# SERVICE PROCEDURE

**SUBJECT:** SAFETY RECALL 22524 Variation 22554  
Hex Flange Lock Nut on certain International® HX®  
Series trucks built on 07/21/2022 thru 07/22/2022.

### **VEHICLE RECALL 22554**

**Figure 1. Sheppard Main Steering Gear Mounting Nuts (Driver-Side)**

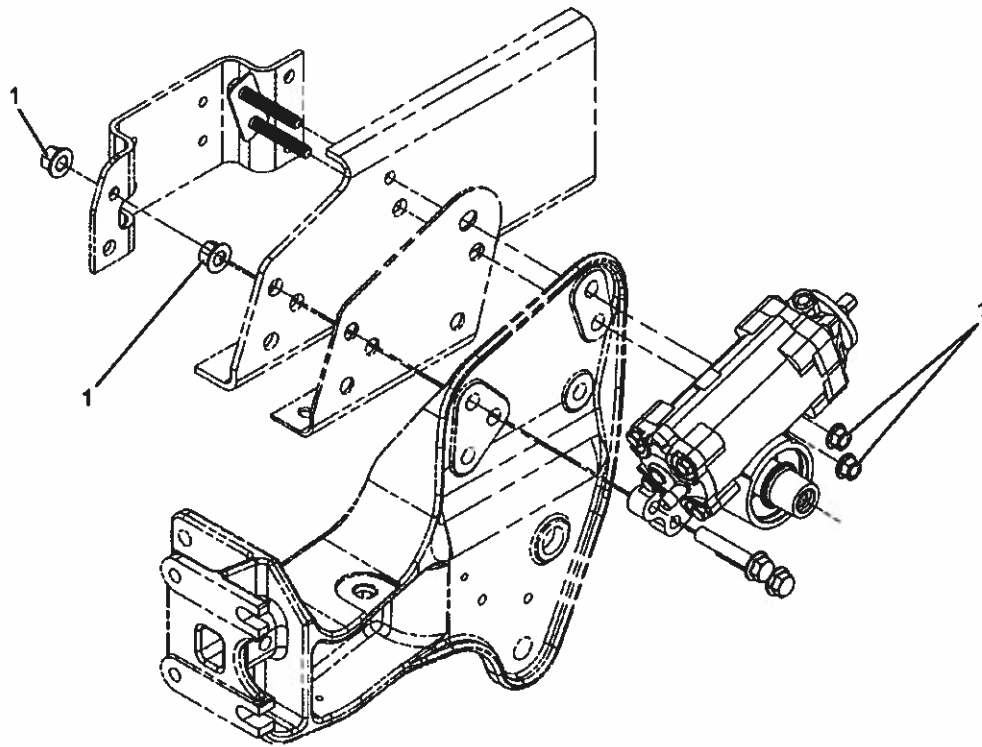
A specific hex flange lock nut used in several, but not all, steering and/or suspension locations may have not been properly formed and heat treated to Navistar's specifications and can result in a loss of joint tension as the vehicle ages. A loss of joint tension in these joints may affect vehicle handling and could contribute to a vehicle crash.

6. Access main steering gear mounting nuts (Figure 1, Item 1).

7. Remove only one mounting nut at a time. Discard nut.

8. Install new mounting nut.

9. Using a torque wrench and backup wrench positioned on bolt, tighten mounting nut to 330 - 370 lb-ft (450 - 500 N·m).

10. Repeat Steps 7-9 for additional mounting nuts.

**Figure 2. HAS Cross Brace Nuts**

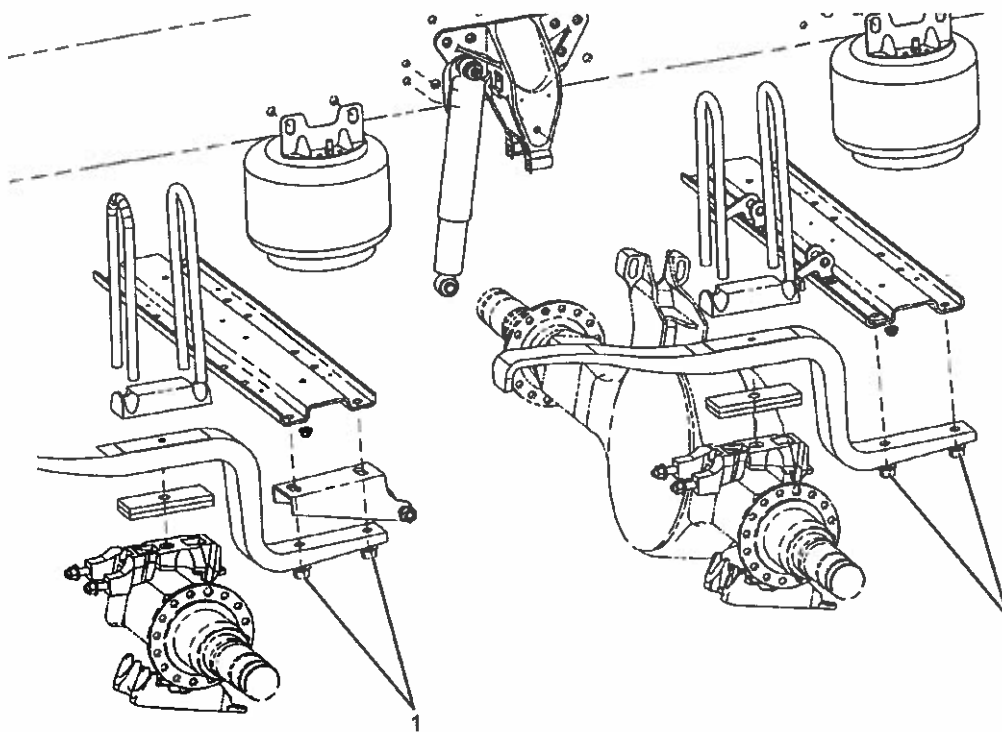
1. Nut (4)
12. Access four nuts (Figure 2, Item 1) securing rear air spring(s) to cross brace.

13. Remove and replace nuts. Using a torque wrench, tighten nut to 330 - 370 lb-ft (450 - 500 N·m).
14. Repeat Steps 12-13 for opposite side.
15. Raise vehicle, remove jack stands, and lower vehicle.
16. Close and latch hood.
17. Remove wheel chocks.
